**PD Modification Application: MM 24-1044**  
**Zoning Hearing Master Date: October 28, 2024**  
**BOCC Land Use Meeting Date: December 10, 2024**

<p><b>GENERAL DEVELOPMENT PLAN</b></p> <p><b>MM-24-1044 MILK AND ORIENT INDUSTRIAL</b></p> <p>4015 ORIENT ROAD TAMPA, HILLSBOROUGH COUNTY, FLORIDA 33610</p>	<p>PROJECT NO. 24-1044</p> <p>DATE: 08/28/24</p> <p>SCALE: 1" = 40'</p>
--	---

## AGENCY REVIEW COMMENT SHEET

8.2 Proposed Site Plan (Full)

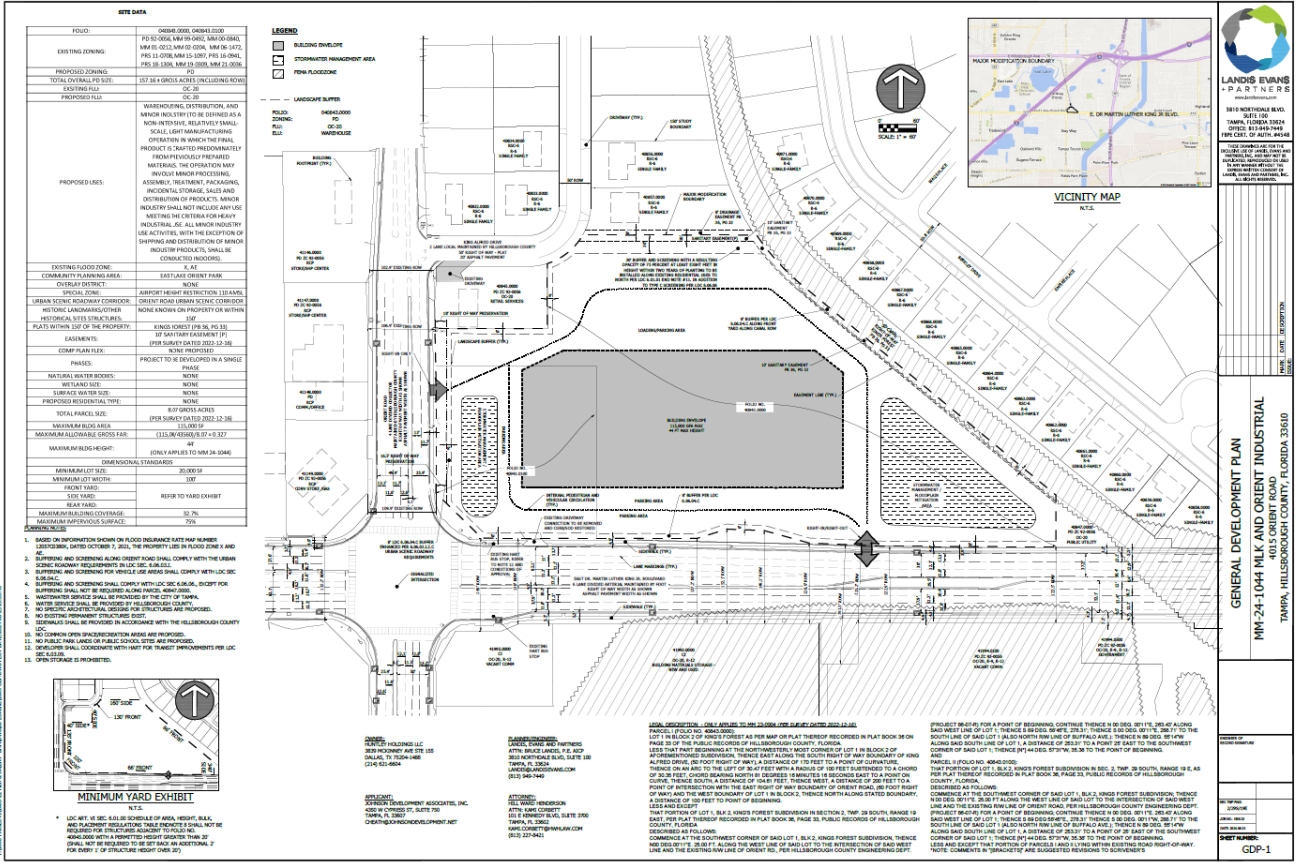
Prior to certification, the label stating the proposed buffer and screening along the east PD boundary shall be removed from the site plan.

- At the time of site development, the developer shall remove existing driveways identified on the PD site plan, and restore to curb, gutter and sod consistent with the existing roadway section detail.

- Notwithstanding anything shown on the PD site plan or the conditions of approval to contrary, pedestrian cross access shall be provided to the adjacent commercial parcel at the corner of Orient Rd. and King Alfred Dr.

- As Orient Rd. is shown on the Hillsborough County Corridor Preservation Plan as a future 4-lane roadway, the developer shall preserve a range of +/- 16.5 and 18 feet of right-of-way along its Orient Rd. frontage for future improvements, as shown in the PD site plan. Only those interim uses allowed by the Hillsborough County Land Development Code shall be permitted within the preserved right-of-way. Building setbacks shall be calculated from the future right-of-way line.

- Prior to certification, the applicant shall revise the proposed PD site plan to include a Planning Note stating that "Parking shall be provided consistent with the County Land Development Code requirements".

DRAWING NO. **TS-6**  
SHEET NO. 1 OF 1

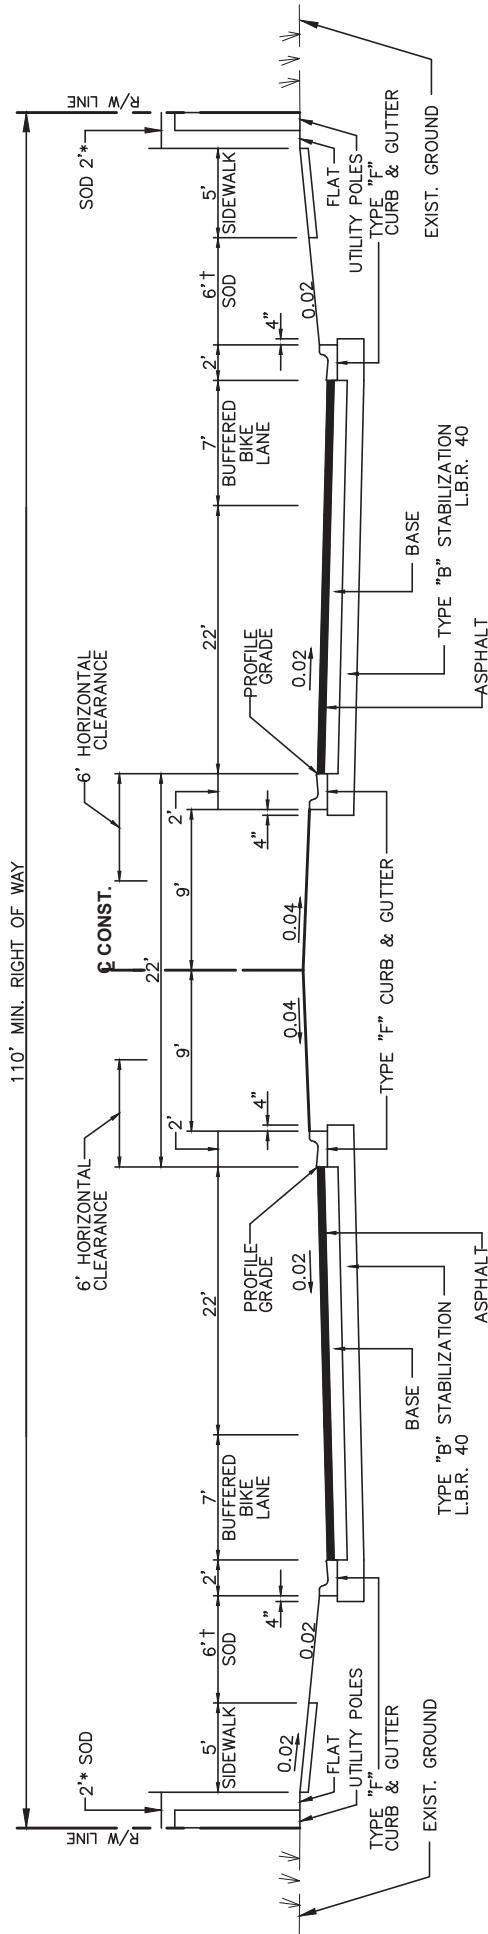
According to the Hillsborough County Transportation Technical Manual a TS-6 urban collector roadway typical section has 11-foot lanes with buffered bike lanes, curb, gutter and sidewalks on both sides within a minimum of 110 feet of right-of-way. The applicant has submitted a Design Exception to make improvements to Orient Rd., consisting of 90 foot northbound right turn lane in to the project site. See additional detail under the section titled "Requested Design Exception" found herein.

CROSS ACCESS EXHIBIT  
MM-23-0904 MLK AND ORIENT INDUSTRIAL  
4015 ORIENT ROAD  
TAMPA, HILLSBOROUGH COUNTY, FLORIDA 33610

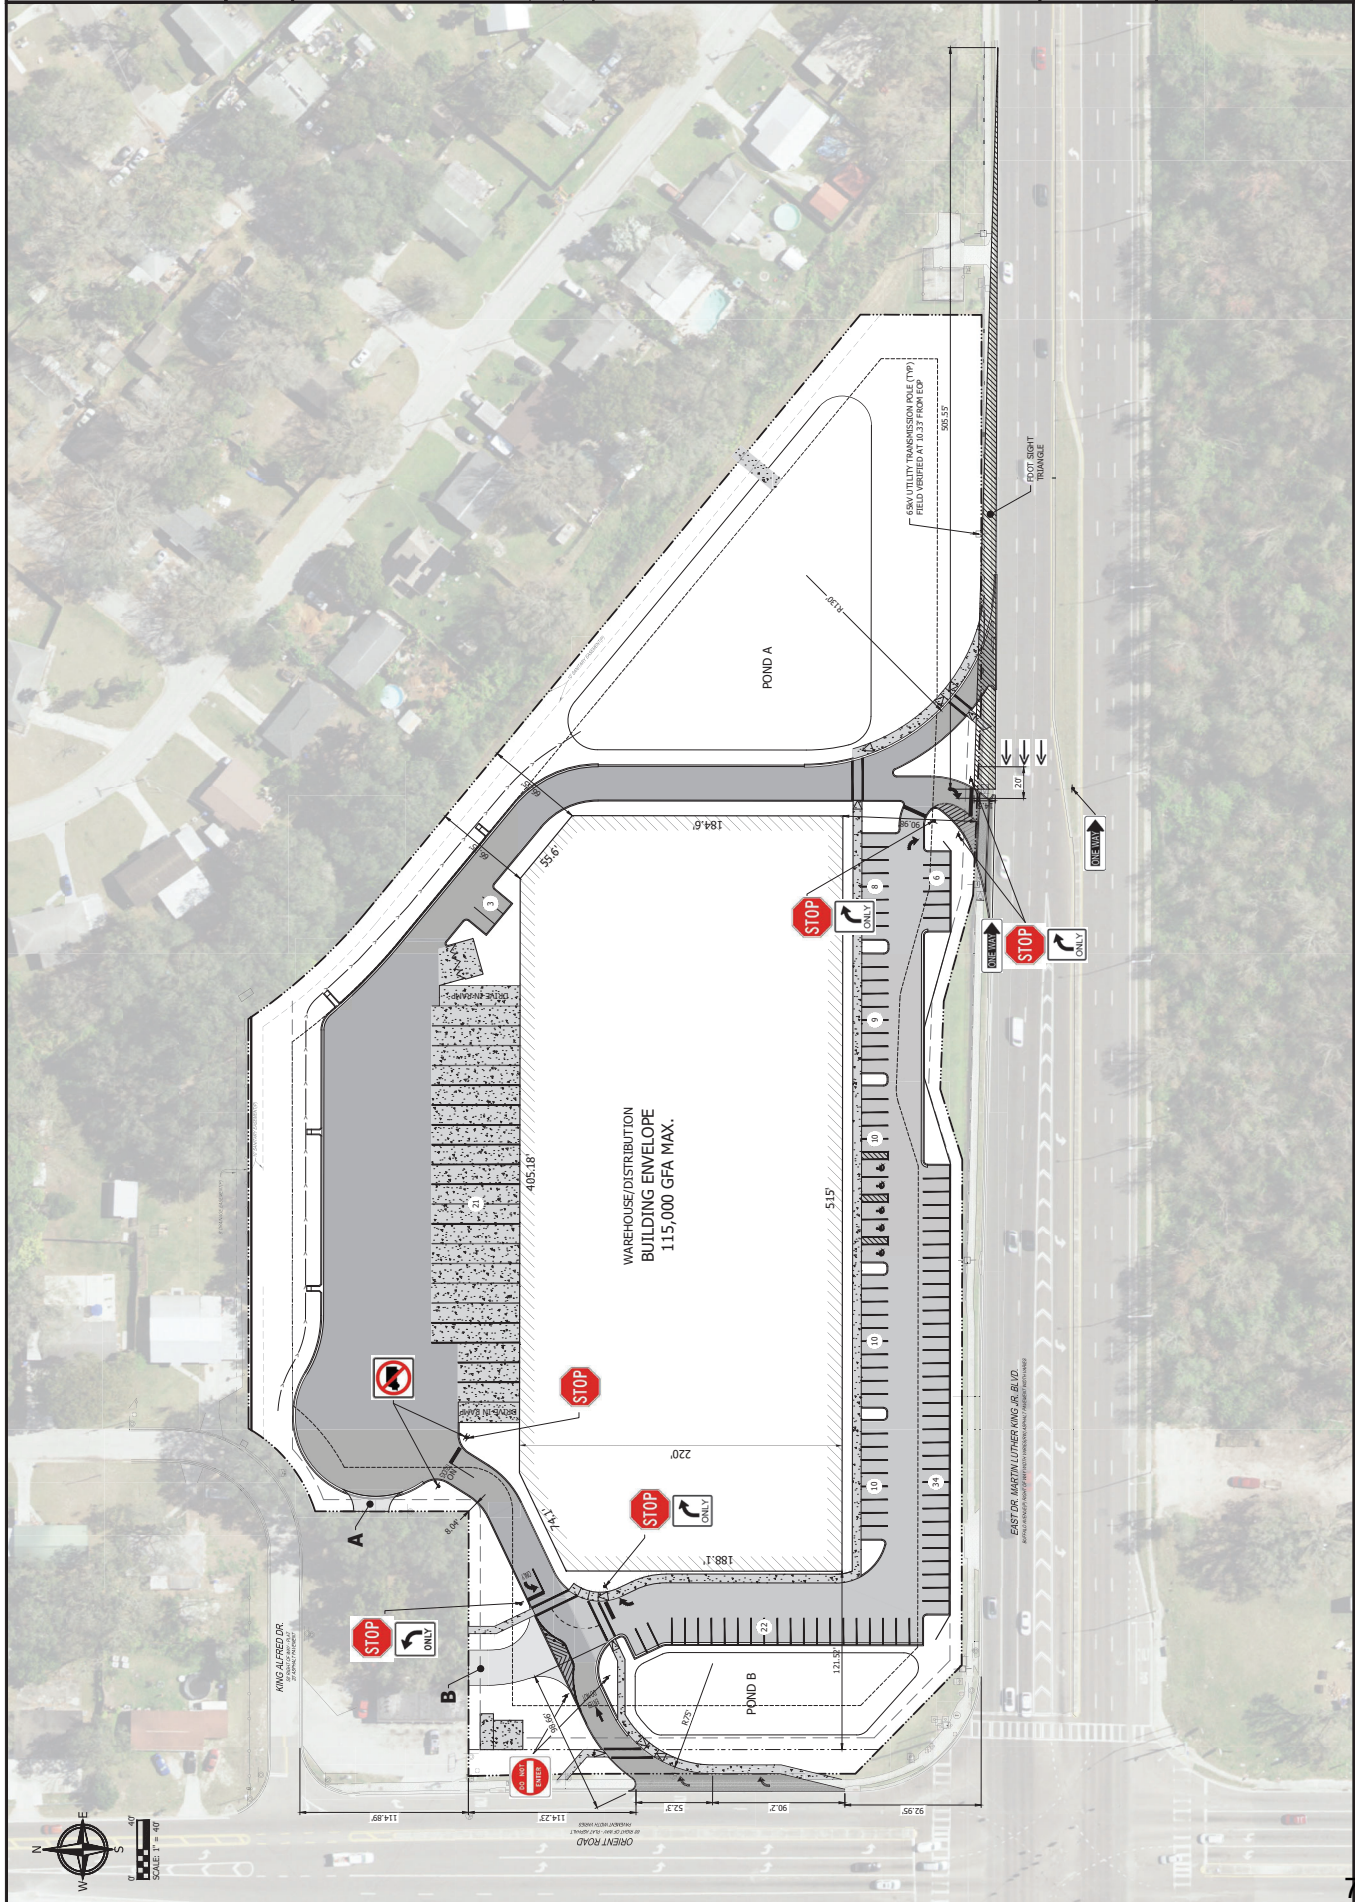
The applicant's EOR submitted a Section 6.04.02.B. Administrative Variance request (dated July 15, 2024) seeking relief from the Section 6.04.03.Q requirement to provide vehicular cross access to the adjacent commercial property fronting Orient Rd. On October 4, 2024, the County Engineer found the variance approvable. As such, no vehicular cross-access connection would be required. Notwithstanding anything shown on the PD site plan or the conditions of approval to contrary, pedestrian cross access shall be provided.

Due to the layout and access configuration for the project, there is not a good location for the cross-access. The cross-access to the west (A) as shown in Figure 1, would require

Given the size of the retail parcel, the amount of cross-access vehicles would be minimal; therefore, it would not be detrimental to the public health, safety and welfare.

Without this variance, vehicles would have to traverse the truck court or potentially impact the access to Orient Road, therefore without the variance, reasonable access cannot be provided.
